Prop Idn: 30646 OLD RANCH CANYON 7 FEDERAL Well No: 7

APPLICATION FOR PERMIT TO DRILL OR DEEPEN

SUNDRY NOTICES AND REPORTS ON WELLS

| 8. Well Name and No. | Old Ranch Canyon "7" Federal #7 |

WELL LOCATION AND ACREAGE DEDICATION PLAT

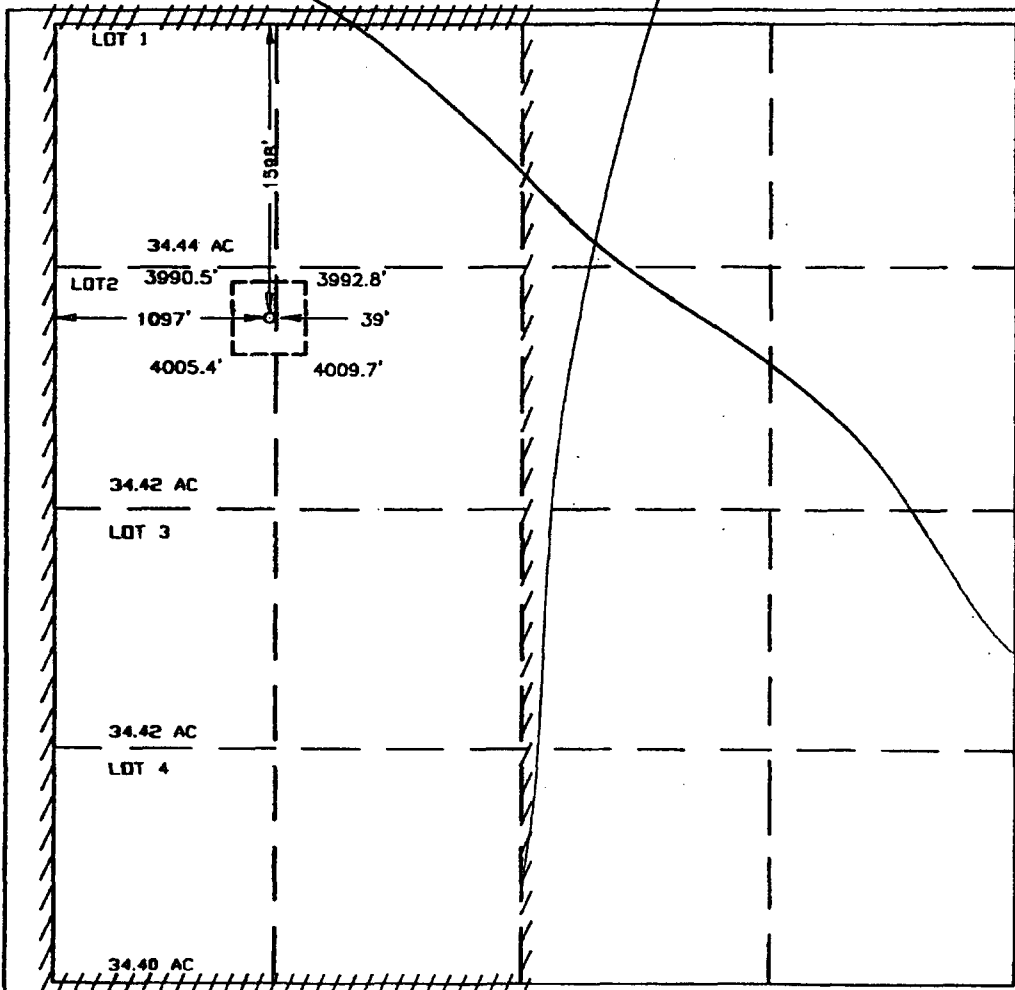
At this time Devon Energy wishes to inform you that we are changing the drilling program for the Old Ranch Canyon "7" Federal #7 from a proposed vertical drill to directional with the chosen bottom location as indicated on the plat. Attached please find the following.

1. Well Location and Acreage Dedication Plat (NMOCD form C-102)
2. Directional 7" casing string design sheet
